Appl. No. 09/802,356  
Amdt. Dated 03/07/2005  
Reply to Office action of 12/09/2004

**Amendments to the Drawings:**

### **REMARKS/ARGUMENTS**

FIG. 2A

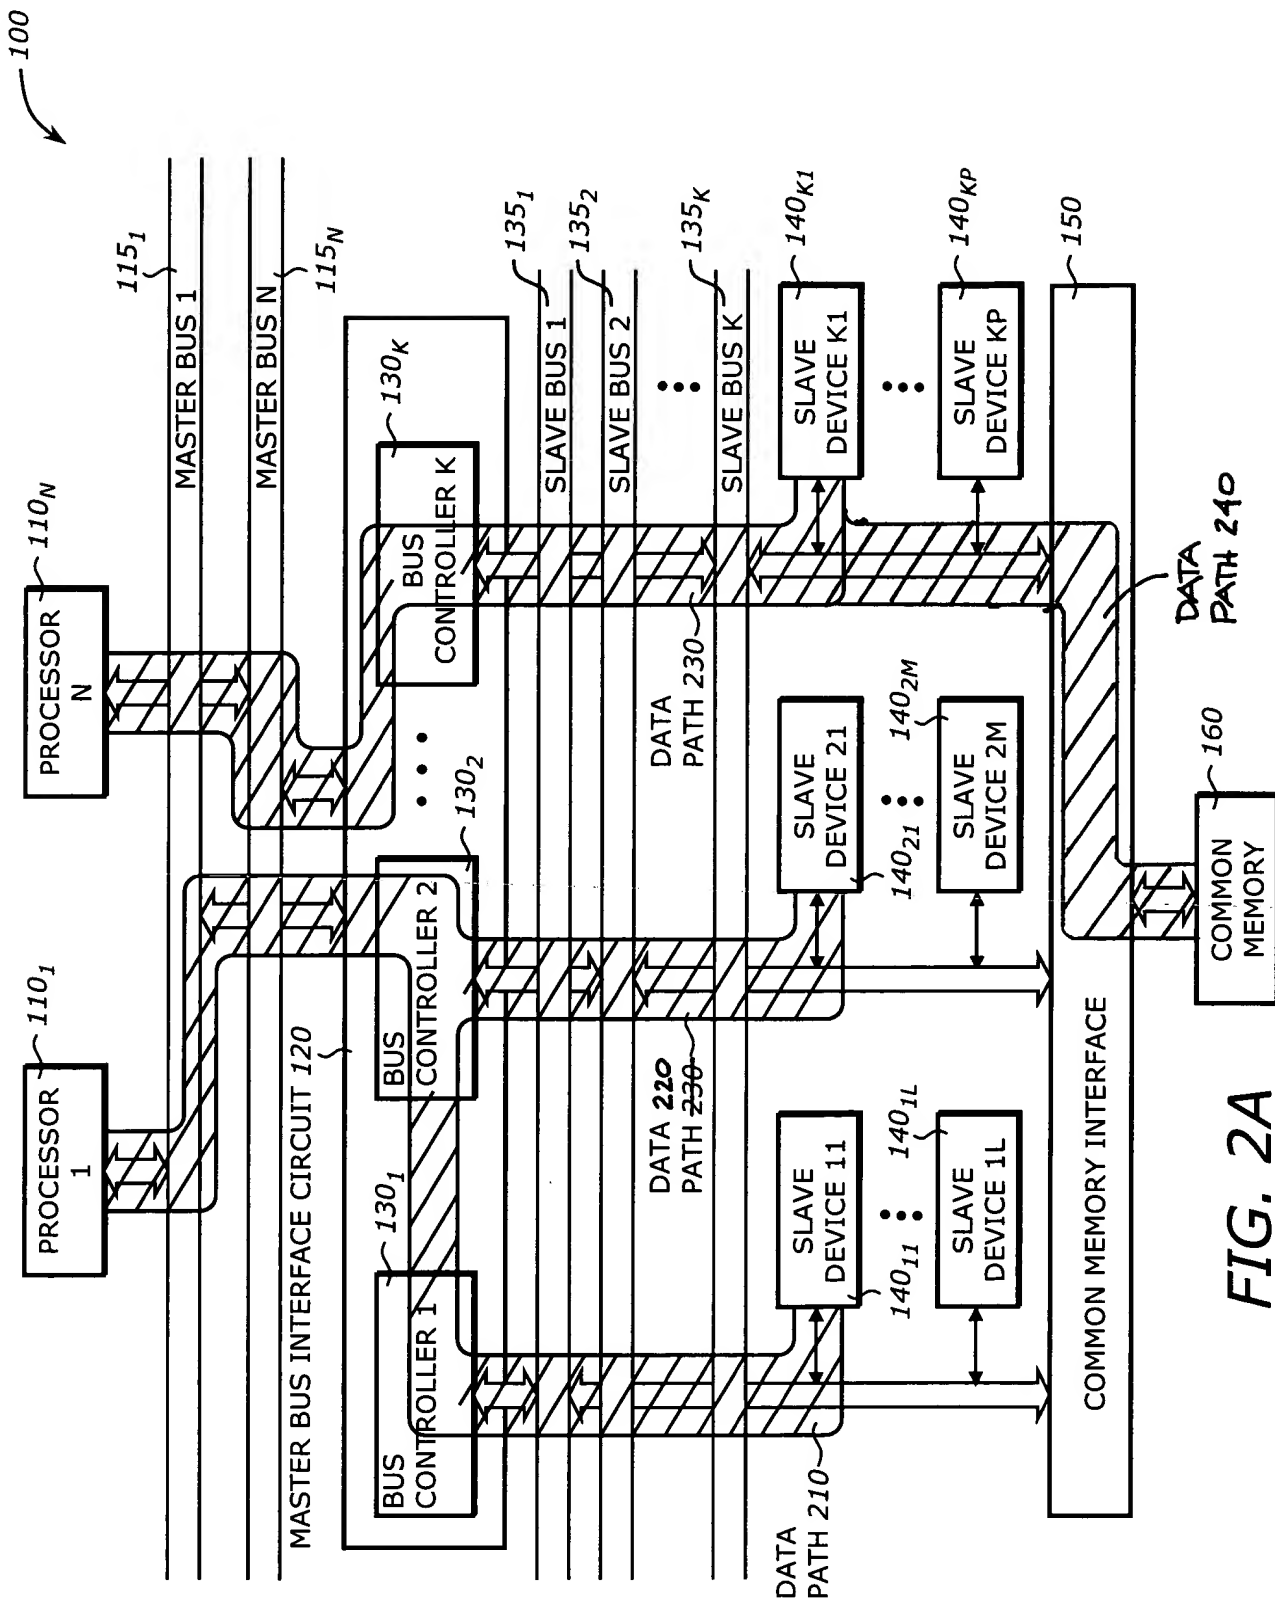
The attached sheet of drawing includes changes to Fig. 2A.

1. The Examiner objected to the drawings due to minor informalities. In response, Applicants have amended the drawings accordingly. The data path 230 is re-numbered 220 and the data path 240 is included. Therefore, Applicants respectfully request the objection be withdrawn.
